STATE OF VERMONT AGENCY OF TRANSPORTATION			
Town Of	HARTFORD	Bridge No.	11N & 11S
Highway No.	1-89 NB & SB	Log Sta.	
		Surv. Sta.	
1-89 NB & SB OVER WHITE RIVER, VT 14 & NECR			
DOWNSPOUT DETAILS			
Designed By	S.M. HODGDON	Drawn By	B.J. MASSE
Checked By	T.S. BRYANT	Bridge Design Supervisor	C.D. BAKER
Date	9/98	Date	9/98
PROJECT	HARTFORD	PROJECT NO.	IR 089-1(13)
VHB Cad Filename	50699DS	Bridge Sheet No.	17
		Sheet	17 of 101

**SIDE ELEVATION**  
SCALE: 3/4" = 1'-0"

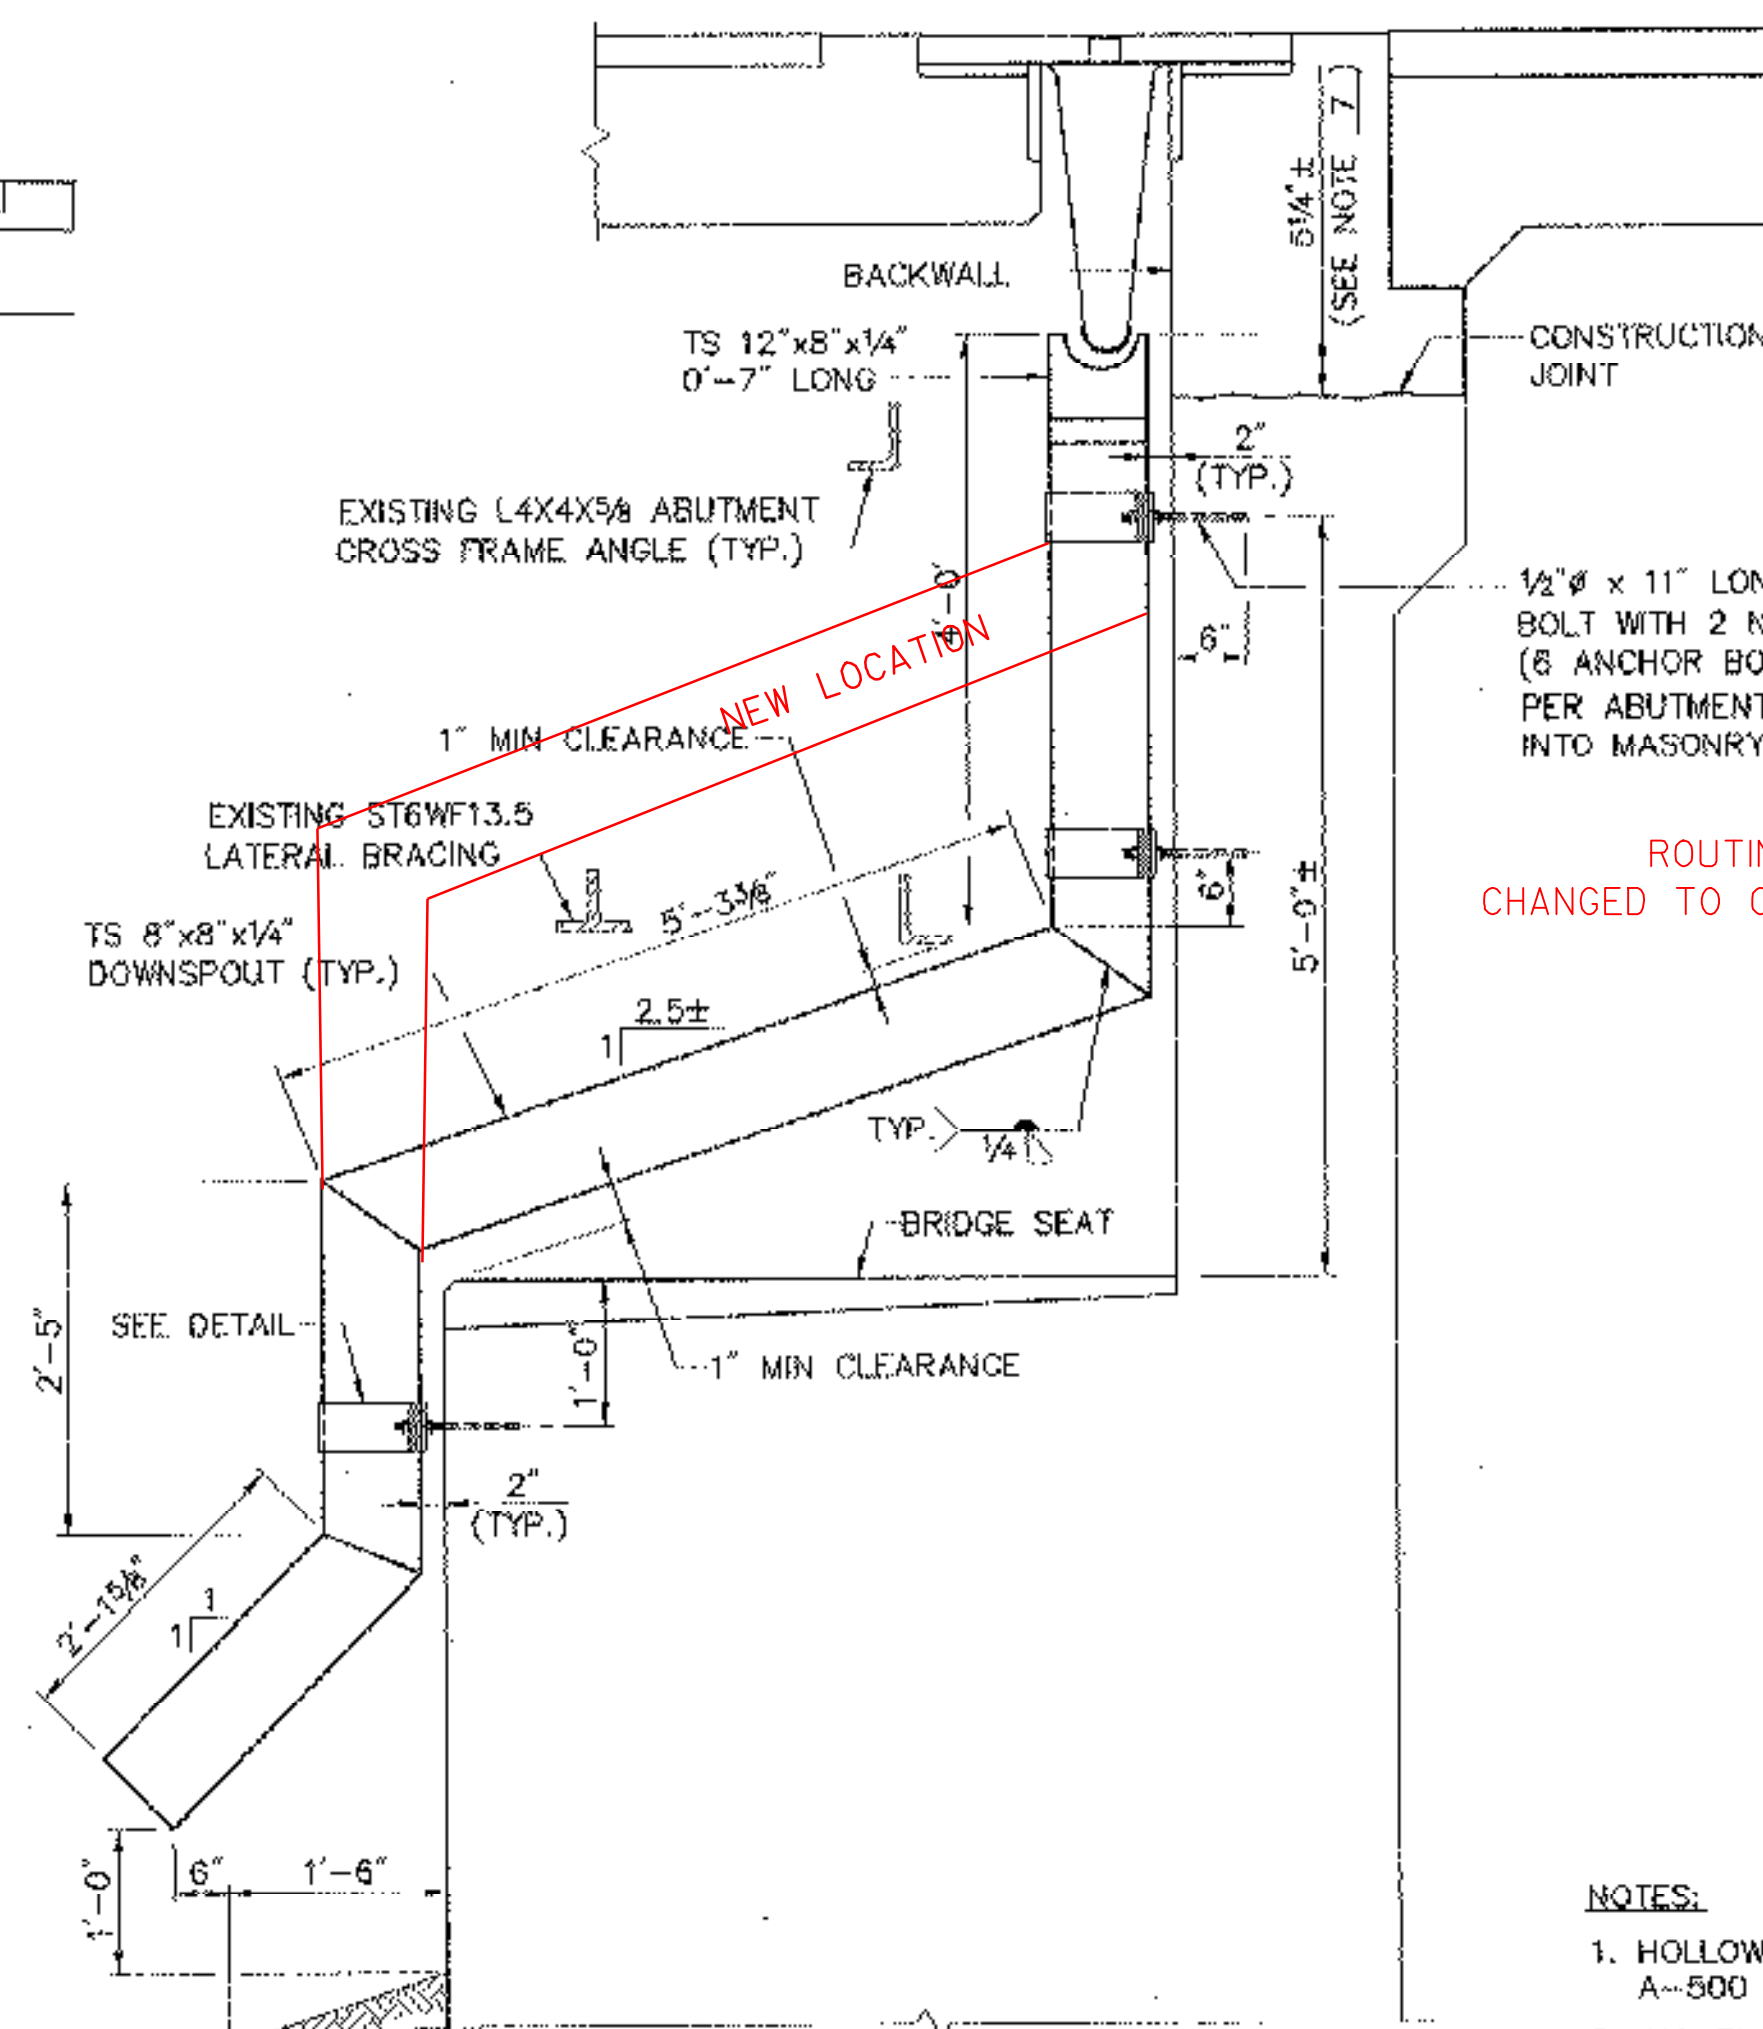
ROUTING OF DOWN SPOUT TUBE CHANGED TO CLEAR CROSS FRAME AND BRACING
